DC-DC ("BOOST INDUCTOR") Layout is important for minimizing ground bounce  
Looking to have some patchwork near the output

Ver B to Ver C - added compensation resistors, changed inductor footprint

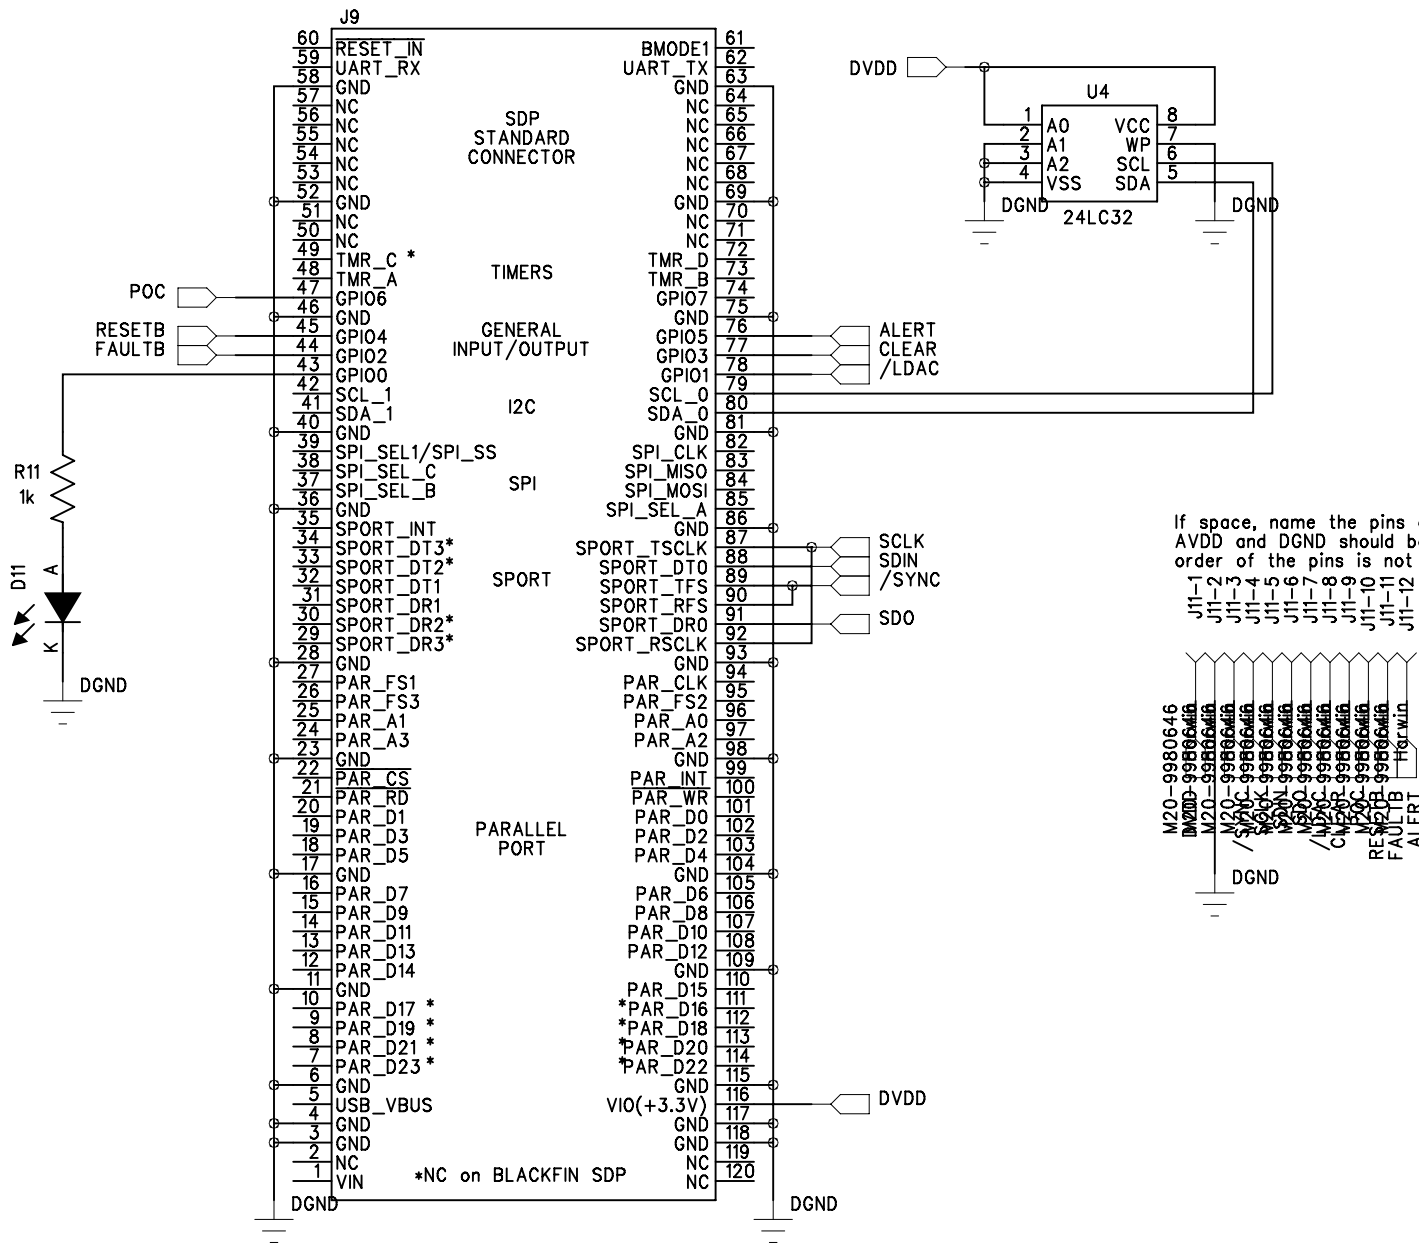
If space, name the pins on this connector  
AVDD and DGND should both be on one end of the connector, otherwise the  
order of the pins is not important
